**Re: Minor Project Refinement No. 21 for the South Orange County Reliability Enhancement Project.**

## South Orange County Reliability Enhancement Project CPUC Minor Project Refinement Form

**Report No.:** 21

**ATTACHMENT B**  
**MPR-21 Figure**

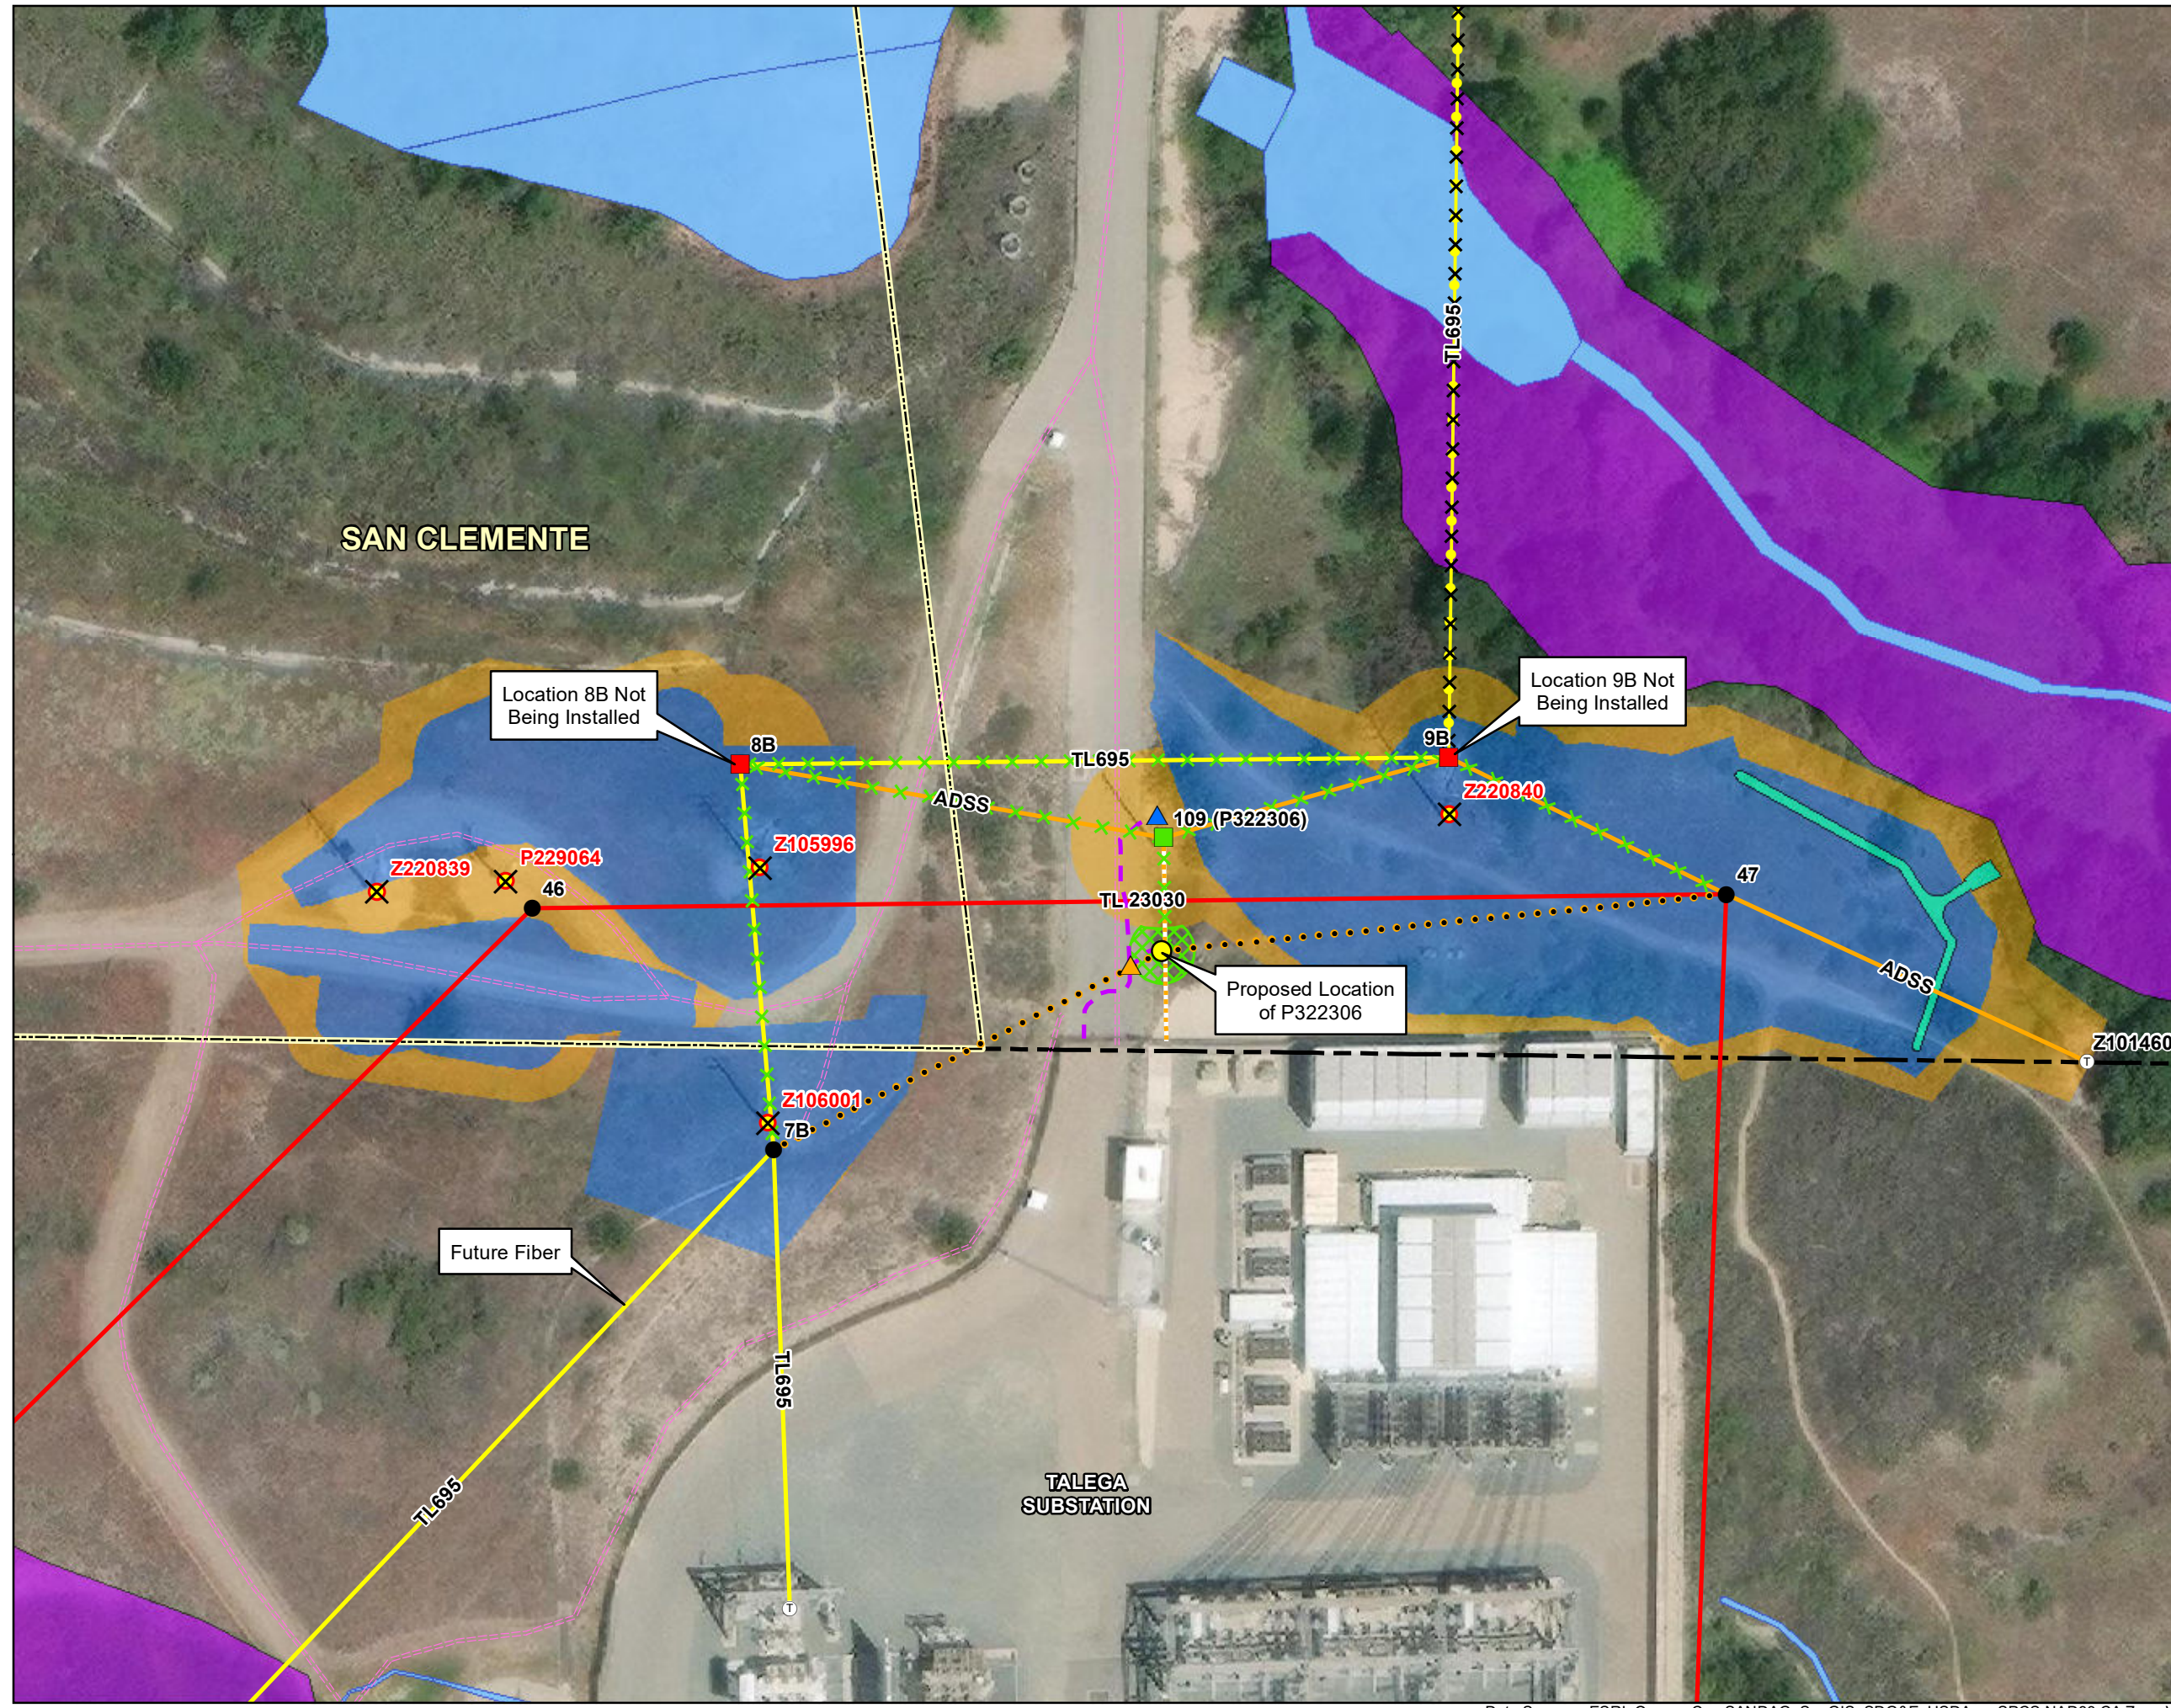
San Diego Gas and Electric (SDG&E) is requesting approval of MPR-21 for the use of a new work area for the South Orange County Reliability Enhancement Project (SOCRE or Project). The new work area is contiguous with previously approved Project components in Notice to Proceed No. 7 (NTP-7) as shown in **Attachment B, MPR-21 Figure**. The new MPR-21 work area will total approximately 290 square feet (0.007 acre).

The MPR-21 work area will be utilized for the repositioning of Location 109 (existing distribution pole P322306) approximately 35 feet south of the existing P322306 location. The MPR-21 work scope includes the installation of a new handhole within the paved road located west of the new pole location. The original scope for P322306 consisted of overhead work on the existing P322306 pole and potential underground work for maintenance of the All-dielectric Self-supporting (ADSS)

Final engineering has eliminated the need for the installation of Locations 8B and 9B, therefore, the proposed overhead alignment for the ADSS communications cable will extend between Z294103 within Location 47 to the new P322306 location prior to being undergrounded in the new handhole located within the road west of the new P322306 location. Future fiber will come in from the west and connect Z120029 in Location 7B to the new P322306 replacement location. Overhead work already accounted for in NTP-7 will take place at Locations 47 and 7B utilizing bucket trucks staged within the existing maintenance pads and access roads to accommodate this adjustment.

Justification for Change: Following final engineering and constructability review in the field, it was determined that Locations 8B and 9B no longer needed to be installed as part of the Project. As a result, reconfiguration of the overhead alignment for TL695 and TL23030 was required. This reconfiguration has necessitated an adjustment of the overhead ADSS communications cable. The relocation of P322306 35 feet south is therefore being proposed which results in a safer overhead configuration that reduces overlap of energized wire between the existing TL23030 line and the overhead ADSS communications cable. If the existing P322306 pole were to remain in place, the proposed overhead ADSS communications cable would cross underneath the overhead 230-kilovolt (kV) line (TL23030) in two separate areas between Locations 7B and 47, posing an increased safety risk. A new handhole is required west of the new P322306 location. Trenching will be required through the paved road north of the Talega Substation to the new handhole location, as well as from the new handhole location to the existing handhole located north of the existing P322306 location. This trenched pathway is required in order to implement the underground connection requirements.

**Photograph 3:**

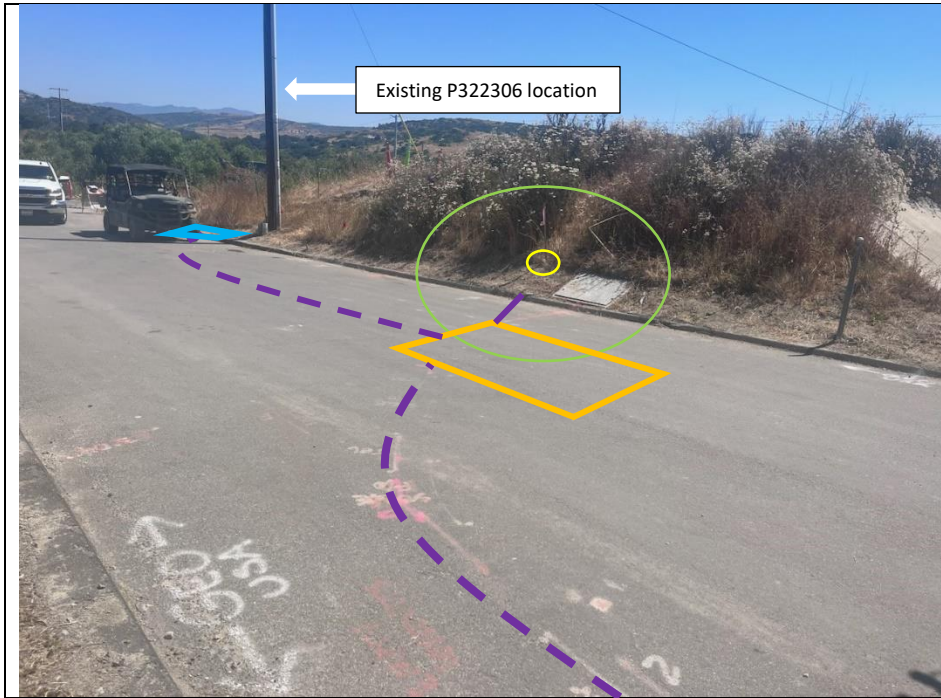
Trenching (indicated by purple dashing) will occur within the existing road bed from the northern perimeter of the Talega Substation to the new handhole (orange polygon) that will be installed west of the MPR-21 work area (green circle). Trenching will then occur from the new handhole to the existing conduit (blue polygon) located 8 feet north of the existing P322306 location. Facing: Southeast.
